Access Compliance Report

Public Rights-of-Way

Intersection ID: 11512	Main Street: N_SMITH_ST	Cross Street: W_7TH_ST	Location: N
ADA ID: D2AC4EF70B38	Ramp Type: PerpDiag	Initial Pass/Fail: Fail	Overall Compliance: No
		Severity Score: 55

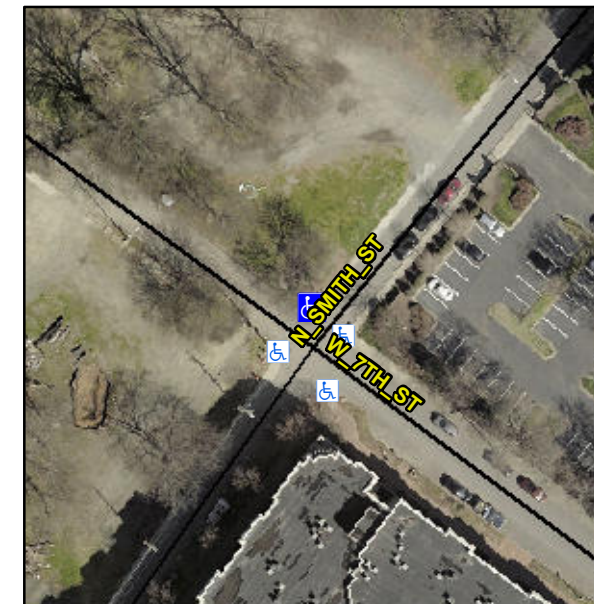
R304.5.1, R304.2.2, R304.5.3

Compliance	Description	Data	Compliance	Description	Data
N/A	Ramp Length (in)	50.0	No	Ramp Slope (%)	8.7
No	Ramp Width (in)	32.0	No	Ramp XSlope (%)	8.1
N/A	Flare Type LT	N/A	N/A	Flare Type RT	N/A
N/A	Flare Slope LT (%)	N/A	N/A	Flare Slope RT (%)	N/A
N/A	Flare Traversable LT?	N/A	N/A	Flare Traversable RT?	N/A
N/A	Landing Length (in)	N/A	N/A	DWS Provided?	N/A
N/A	Landing Width (in)	N/A	N/A	DWS Contrast?	N/A
N/A	Landing Slope (%)	N/A	N/A	DWS Length (in)	N/A
N/A	Landing X Slope (%)	N/A	N/A	DWS Full Width?	N/A
N/A	Landing Curb? (Y/N)	N/A	N/A	DWS Offset (in)	N/A
N/A	Shared Landing?	N/A			
N/A	Gutter Ponding?	N/A	N/A	Gutter Slope (%)	N/A
N/A	Gutter Lip Ht (in)	N/A	N/A	Gutter X Slope (%)	N/A
N/A	Painted X Walk1?	No	N/A	Painted X Walk2?	No
	X Walk 1 Direction	To SW		X Walk 2 Direction	To SE
N/A	X Walk 1 Width (in)	N/A	N/A	X Walk 2 Width (in)	N/A
	X Walk 1 Slope (%)	3.5		X Walk 2 Slope (%)	2.3
	X Walk 1 X Slope (%)	5.5		X Walk 2 X Slope (%)	1.2

Remove & Replace Curb Ramp With Two New Directional Ramps or Equivalent.
